SUBJECT: DAVIS-BESSE NUCLEAR POWER STATION, UNIT 1 - ISSUANCE OF
AMENDMENT (TAC NO. MB8953)

Amendment No. 257
License No. NPF-3

SAFETY EVALUATION BY THE OFFICE OF NUCLEAR REACTOR REGULATION
RELATED TO AMENDMENT NO. 257 TO FACILITY OPERATING LICENSE NO. NPF-3
FIRSTENERGY NUCLEAR OPERATING COMPANY
DAVIS-BESSE NUCLEAR POWER STATION, UNIT 1
DOCKET NO. 50-346

Figure 1. Full Power, High Decay Heat Post LOCA Representative Pressure-Time Histories

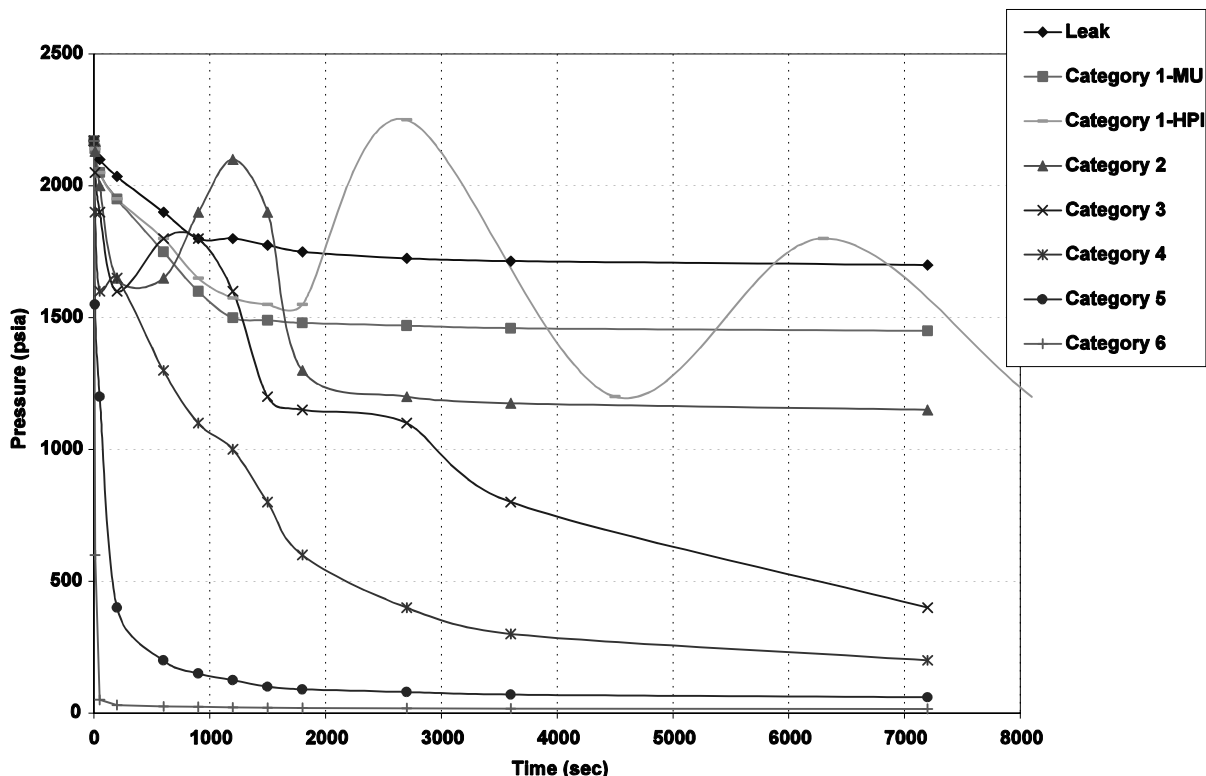
RCS pressure behavior for each of these categories for initiation of the accident during power operation is illustrated in Figure 1.

Figure 1, a leak may be characterized by a small initial decrease in RCS pressure, followed by a steady state condition where injection rate and leak rate are in balance.

A LOCA is defined as an RCS pressure boundary break that causes loss of coolant at a rate in excess of MU capability. The behavior of the smallest LOCA category, Category 1, is illustrated by two lines in Figure 1, one with MU pump operation and one without. These smallest LOCA break sizes will depressurize slowly and achieve a reactor trip within the first 10 to 20 minutes following initiation of the break. When MU pump flow is credited with some or all of the operator actions identified for leak mitigation, the RCS characteristics will evolve similarly to those of a leak. However, if only redundant safety-related equipment is used with limited credit for operator actions, as is assumed for a design basis calculation, subcooling margin (SCM) may be lost and the RCS inventory loss can result in an interruption of natural circulation. Loss of natural circulation will result in core boiling and RCS repressurization above the HPI shutoff head. When the RCS pressure is above the HPI shutoff head, the RCS liquid inventory and water level will decrease due to the break flow. When the water level descends into the SG

Category 5 breaks are sufficiently large to depressurize the RCS to approximately the containment pressure as shown in Figure 1. Cold leg breaks in this Category are not large enough to reverse core flow, which would cause the cladding to exceed the critical heat flux upon break initiation. The core is shut down via control rods and cooled during the blowdown transient, which maintains a two-phase mixture that keeps the fuel pin cladding within a few

Figure 2. Mode 3 Low Decay Heat Post-LOCA Representative Pressure-Time Histories

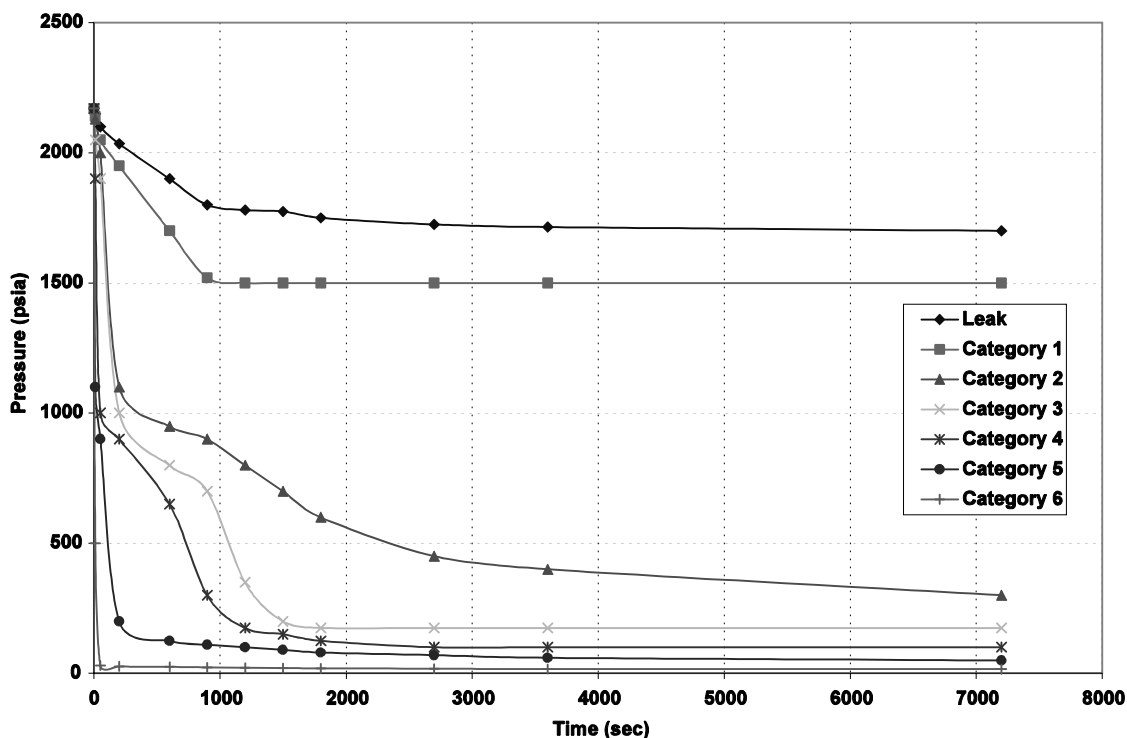
heat generation, the secondary side has no potential to repressurize to the main steam safety valve pressures. Note, however, that if the RCPs are running, RCP heat will require SG heat removal. Typical RCS pressure response for the various break categories is shown in Figure 2.

A leak is successfully managed with operator actions and MU flow as described for the full power analyses. Pressure response to a leak is similar to the response for the full power results in Figure 1. The real differences in the pressure trends are observed for the LOCAs. The Category 1 LOCAs have no potential for RCS repressurization unless the ECCS flow is increased, and the RCS pressure consequently evolves to a pressure at which the ECCS injection matches the break flow. The pressure response will be similar if only HPI is credited or if HPI and MU are both credited. The only difference is, if MU is credited, the quasi-steady RCS pressure trend shown in Figure 2 will be higher for the Category 1 breaks.

Figure 2 shows that some of the smaller LOCAs will remain above the LPI shutoff head for an extended time. Although that is not of concern when long-term HPI operation is ensured, this is not the case for the proposed Mode 3 test conditions. During the proposed test, HPI operability is not ensured after the transfer is made to recirculation flow from the containment emergency sump. Consequently, RCS pressure must be ensured to be below the LPI shutoff head prior to the transfer. Depressurization actions may therefore be necessary that are not considered when the full complement of ECCS pumps is operable.
